**SUBJECT: Forwards response to NRC 990211 RAI re util request for  
amend to secondary containment & SBGTS TS.**

Subject: **WNP-2, OPERATING LICENSE NPF-21  
REQUEST FOR AMENDMENT TO SECONDARY CONTAINMENT AND  
STANDBY GAS TREATMENT SYSTEM TECHNICAL SPECIFICATIONS  
(ADDITIONAL INFORMATION)**

REQUEST FOR AMENDMENT TO SECONDARY CONTAINMENT AND  
STANDBY GAS TREATMENT SYSTEM TECHNICAL SPECIFICATIONS  
(ADDITIONAL INFORMATION)

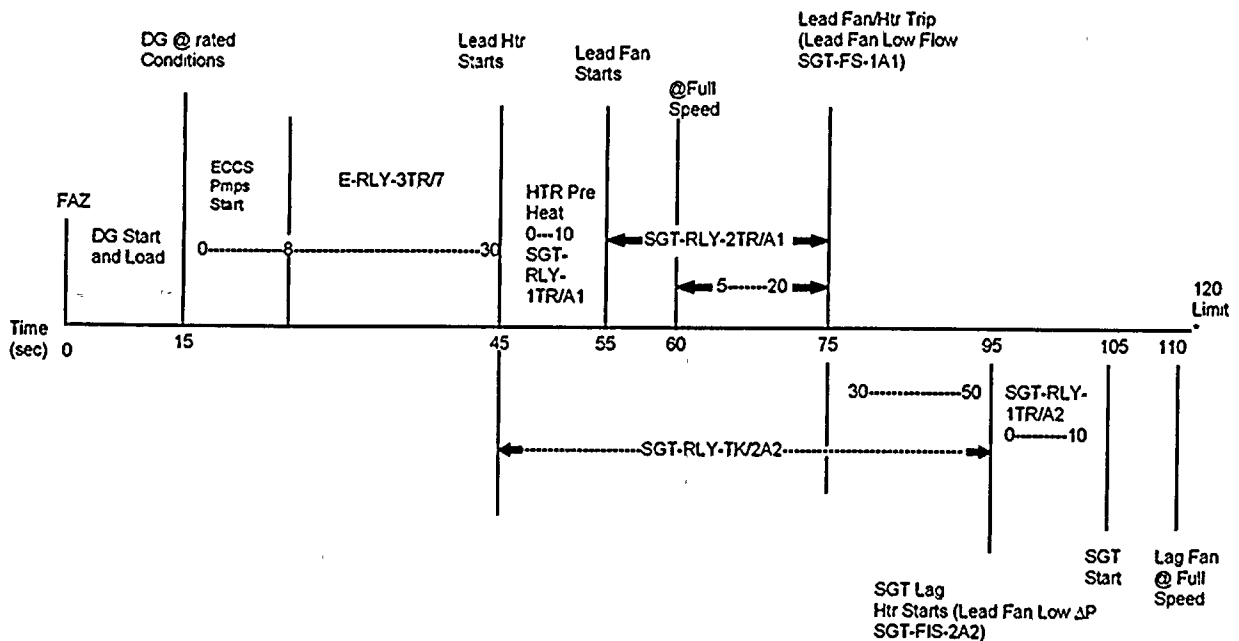
Question 7: It is indicated that the standby gas treatment (SGT) system will not be initiated until 2 minutes after the loss of coolant accident (LOCA). Describe why it is taking so long to start the SGT.

Standard Review Plan Section 6.2.3 states that any delay due to system design in actuating the secondary containment depressurization and filtration system should be considered. The timeline for the start of a standby gas treatment system lead and lag fan following an accident signal is shown as follows:

The timeline shows 15 seconds for an FAZ signal to diesel generator start and load; 30 seconds for sequencing on of the lead standby gas treatment system heater; 10 seconds for heater warm up; 20 seconds for failure of lead fan to develop a minimum flow rate; and 10 seconds for the lag heater to start and warm up, at which time the lag fan would start.
